# Waldringfield Parish Council

WPC response to **DC/25/4781/FUL** - Change of Use of Land for the Siting of 25 Static Holiday Units, 12 Touring Caravan Pitches and ancillary facilities. Land Off, Ipswich Road, Brightwell, Ipswich, Suffolk IP10 0BJ – Planning Officer - M. Kavyani; Deadline 30 January 2026.

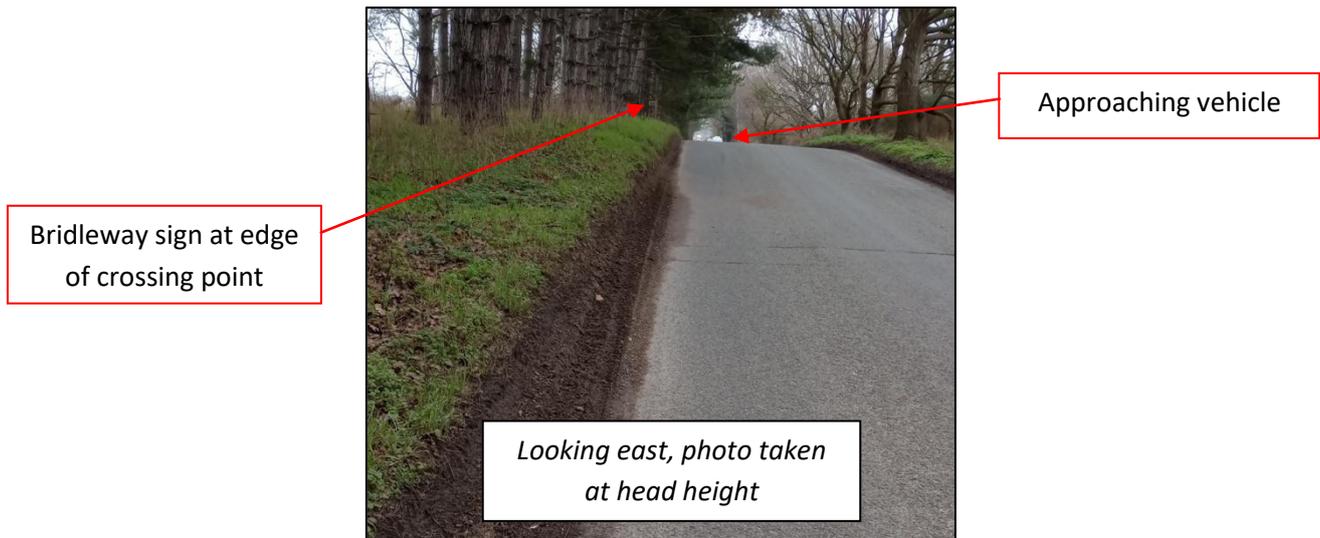
- The new application includes new drawings (2512 305 & 306) showing a potential new pedestrian route off the site and across Ipswich Road. The drawings include photographs to illustrate the visibility splay.

*“In response to updated drawings and photographs demonstrating that 90m splays could be achieved and that the vertical alignment was **relatively flat in the vicinity of the proposed crossing**” (our emphasis).*

- This is misleading as the road is not “relatively flat”, there is a distinctive hump approximately 20 metres to the west of the crossing point which the photographs do not show. This considerably reduces the line of sight to the proposed crossing, for vehicles travelling eastwards.
